Sabre Sailing Association of Australia

Rule Changes passed by Special General Meetings held 30 November 2013 and 15th Feb 2014 which took effect on 1st and 15th February 2014.

SABRE DATUM POINT AND SECTION LOCATIONS

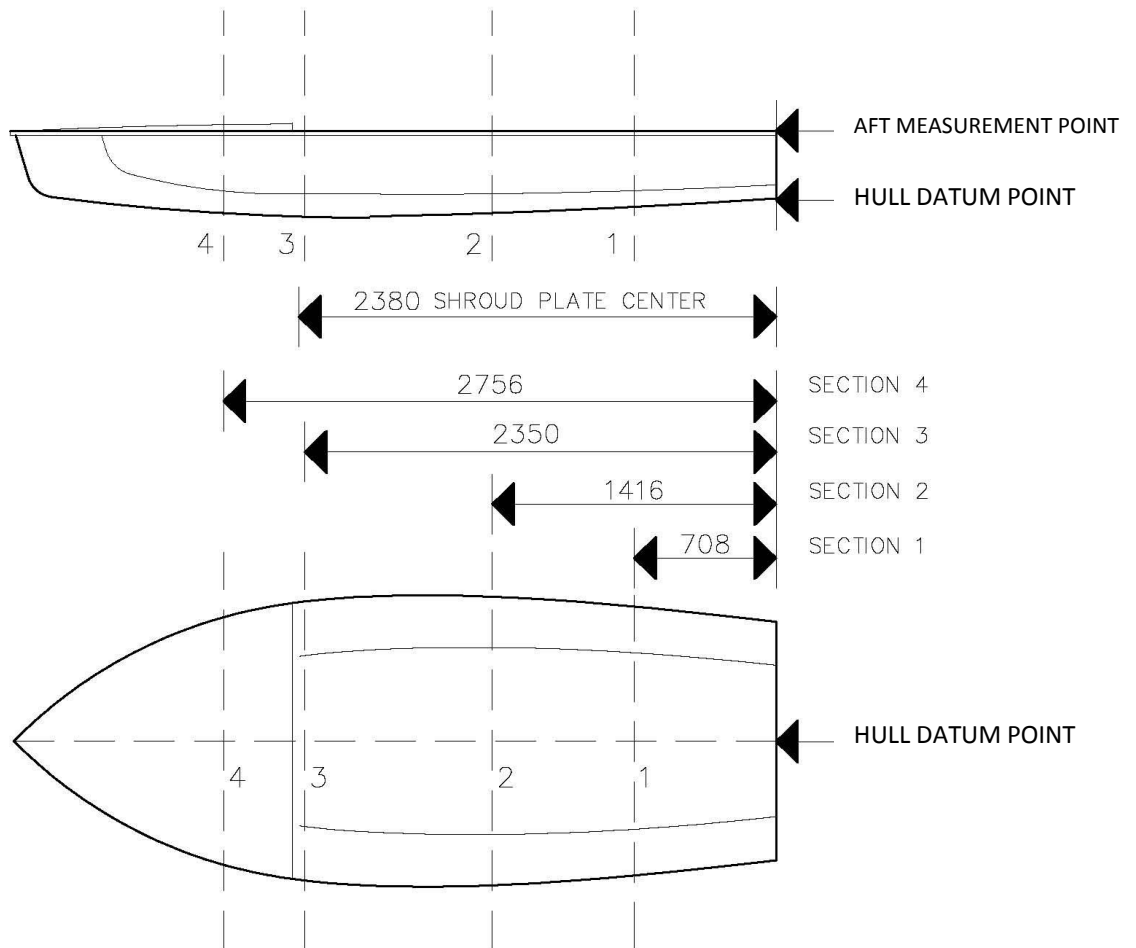
2. Basic Hull Measurement

Where stated, measurements shall be taken from:

Hull Datum Point (HDP): the lowest point of the transom on the centreline where the bottom panels meet transom.

Aft Measurement Point (AMP): is on the plane of the transom at the top of the transom centreline. The angle of the transom to the hull is controlled by the shape of the template for the side panel where the stern end of the side panel forms a right angle.

Forward Measurement Point (FMP): is the projection of the stern at the sheer on the centreline of the hull.

Measurement Sections - The Measurement Sections shall be defined by the following points measured along the hull centreline from either the HDP or AMP as appropriate:.

Section 1 – 708mm from the measurement point.

Section 2 – 1416mm from the measurement point.

Section 3 – 2350mm from the measurement point.

Section 4 – 2756mm from the measurement point.

Diagrams 11 and 12 shown here are to be changed to reflect this;

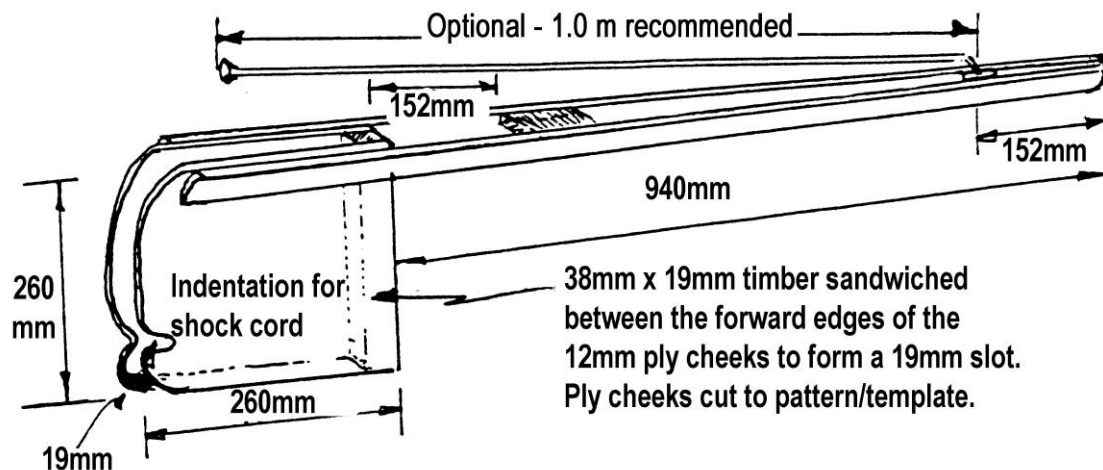
8. Rudder cheek thickness and construction

Diagrams 11 and 12 of the Construction notes refer to 12mm ply rudder cheeks and a 19mm slot. Modern rudder gudgeons have a narrower width which means that the cheeks need to be chiselled out to fit them. 9mm ply cheeks accommodate current commercial gudgeons and do not adversely affect the strength of the rudder stock. Current rules specify that rudder cheeks be made from plywood. There is no reason why the rudder box should not be a moulded FRP construction which is likely to be cost effective and possibly lead to more readily available replacements.

Measurement No. 70 - Rudder box may be constructed from timber or moulded FRP.

Measurement No. 71 - Rudder box cheeks to be a minimum thickness of 9mm.

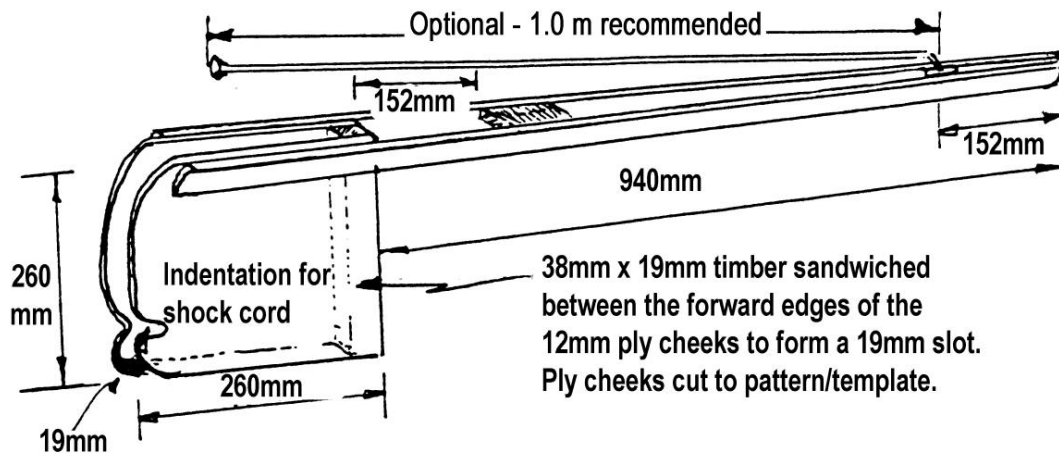
13. Allow outhaul control lines inside the boom.

The boom is not sealed so there is no need for this rule to stop water entry. Allowing an internal control removes the possibility of the outhaul control line fouling on clothing or other items of the boat.

Rule 7.1 (c) as shown below is DELETED;

~~Rule 7.1 (c) - Control lines or halyards are not allowed within the boom section.~~

Diag.#11 - Rudder Stock with Timber Tiller

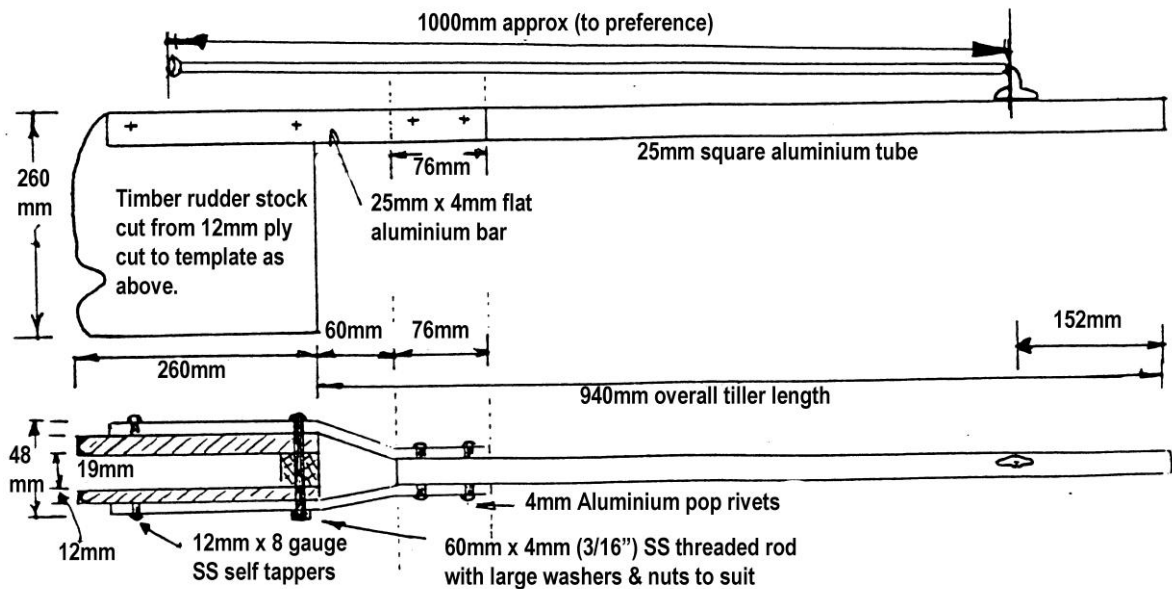
14. Tiller dimensions

The table of measurements (57 to 72) do not contain minimum or maximum lengths for the tiller (timber or aluminium) but Diagrams 11 and 12 on page 26 of the Construction and Fitting Out Notes specify an exact tiller length of 940mm. The length of the tiller, like the tiller extension, **is now a recommendation only.**

Diag.#11 and Diag.#12 shown below are amended;

The recommended tiller length specification is 940mm.

Diag. #22 – Halyard Cleat Position as shown below;

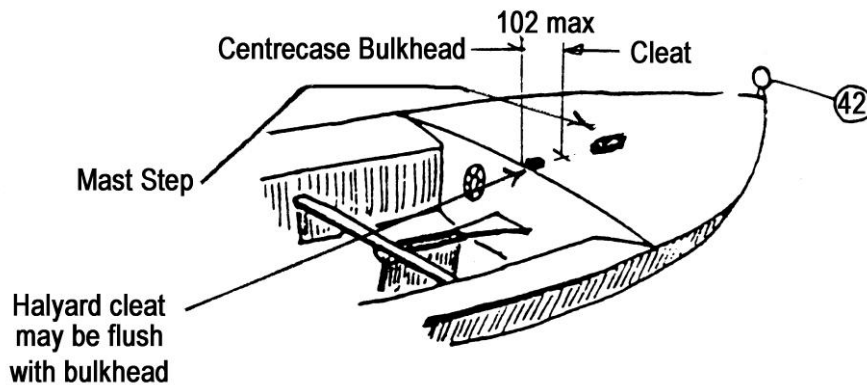
22. Main halyard cleating position (proposals 33 and 50)

There is no clear reason for these measurements and there should be an option to cleat a rope halyard to a cleat attached to the top of the centrecase bulkhead.

Measurements 86 and 87 - DELETED;

Now amended by;

Changing "102 max" to "102mm – recommended" in the diagram.

Last sentence now reads "The cam or clam cleat or halyard lock may be mounted as shown above or on and near the top of centrecase bulkhead."

The words "(Meas #86, Diag. #22, Item 68 or 68A)" are deleted.

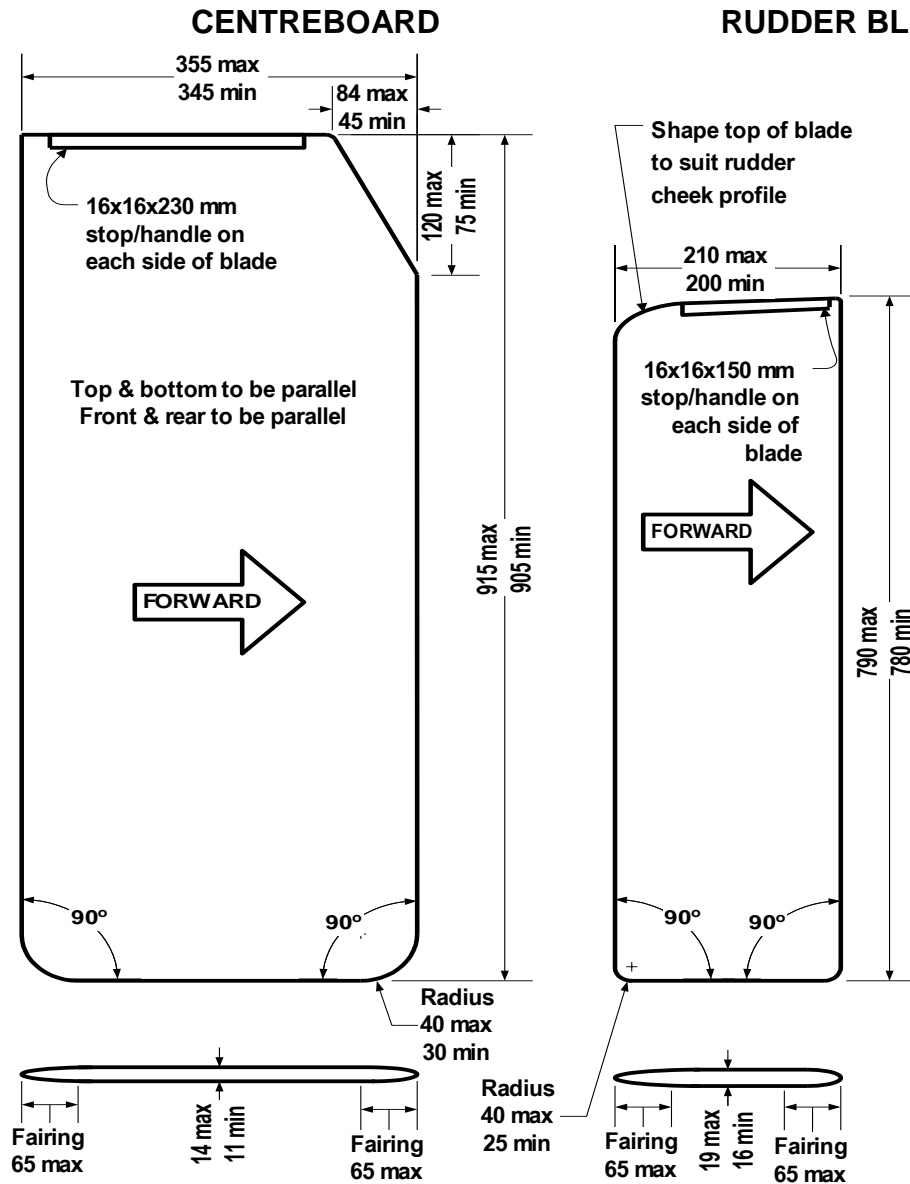
30. FRP Centreboard

Rule 3.1 is Amended as follows;

The following sentence in Step 49 is DELETED

~~These may only be constructed by builders authorised by the SSAA.~~

Diag. #20 – Mainsheet System

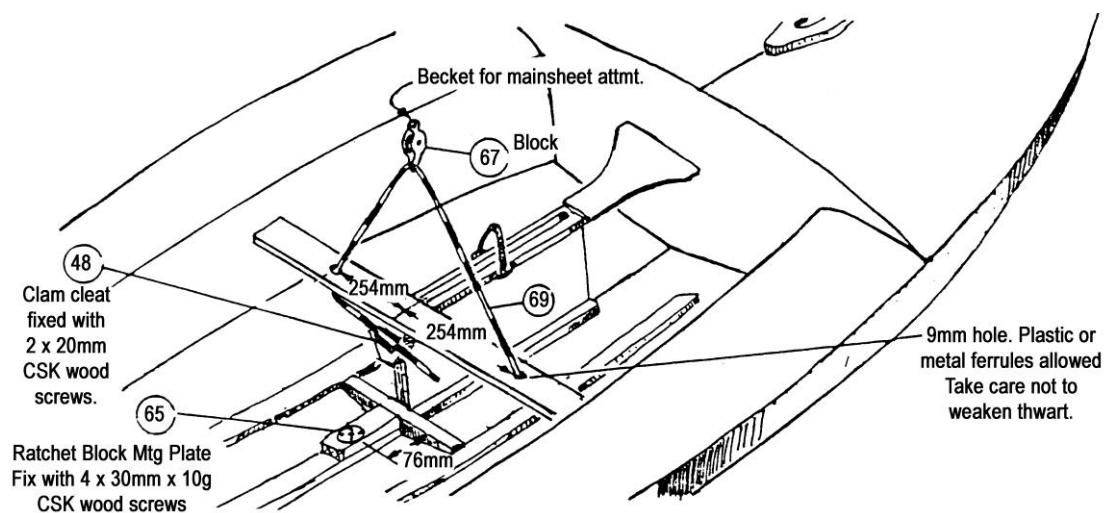
33. Optional position for Mainsheet Ratchet Block and attachment method

Ratchet blocks are optional in the mainsheet system. It was traditional in the 1970's to attach a ratchet block as per Diag #20 but there is no reason why a ratchet block cannot be attached to the boom, or for that matter have one mounted off the keel and another on the boom. Diag #20 does not reflect the modern practice of attaching the last block off the floor by rope strop. Many sailors no longer adjust the rope hawse while sailing and just tie it off, so the requirement for a clam cleat is now formally an option.

Have been amended as follows;

References to fitting 'Item numbers' removed

The 3rd sentence now reads "Fix a knot in one end of the hawse; pass through the first hole in the thwart; through the ferruled end of the mainsheet block (**Item 67**); through the second hole in the thwart, thence optionally to clam cleat fixed to the thwart or tied off to a saddle on the keel.

The sentence "Fit ratchet block and mounting plate to the keel cover block as shown in diagram (**Item 66**)" is deleted.

Diag. #20 deleted.

Diag. #25A – Mast Layout now prefaced by the following:

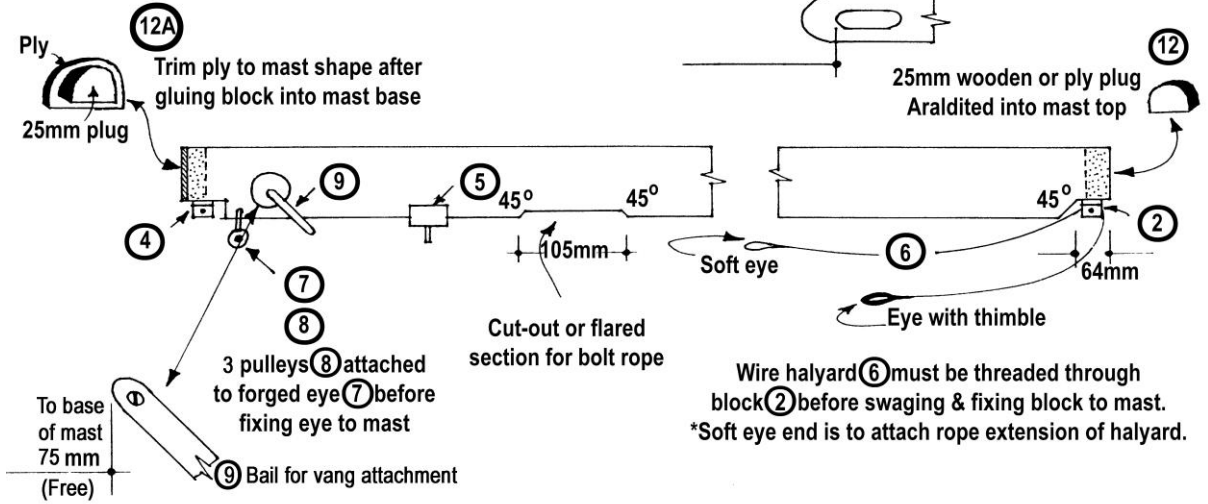
35. Method for attaching shrouds to mast tangs and halyard material – Diag #25A (proposal 54)

The method specified for attaching shrouds to mast tangs in Diag #25A is by permanent swage but common practice is to use cleavis pins or small shackles. The diagram refers to a 'wire halyard' but rope is the most common material these days. The vang attachment point drawing is obsolete.

The following diagram refers to "shrouds swaged to tangs" and "wire halyard". Shrouds may optionally be attached to tangs by using swages, cleavis pins or shackles. The halyard material is optional. The block hanger for attaching the vang shown in Diag #25A is optional.

Diag. #25B – Mast Base Measurements

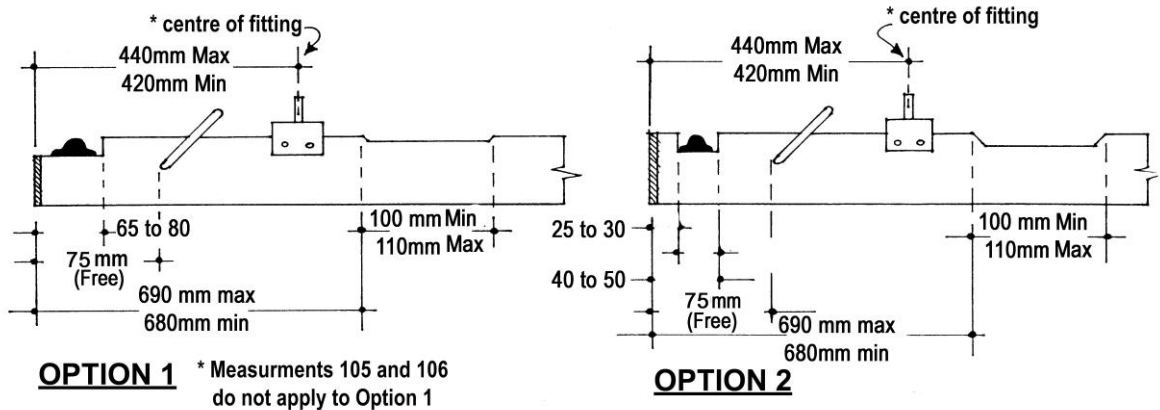
36. Mast vang attachment point incorrectly specified in Diag #25B

The specification for the position on the mast where the vang is attached was deleted Nov 2006) but Diag #25B still shows measurement points. The diagram is now prefaced to indicate that the vang attachment measurements are a guide only.

The method of attaching the vang to the mast is optional and the positions shown in Diag #25B (showing use of a block hanger) are a guide only.
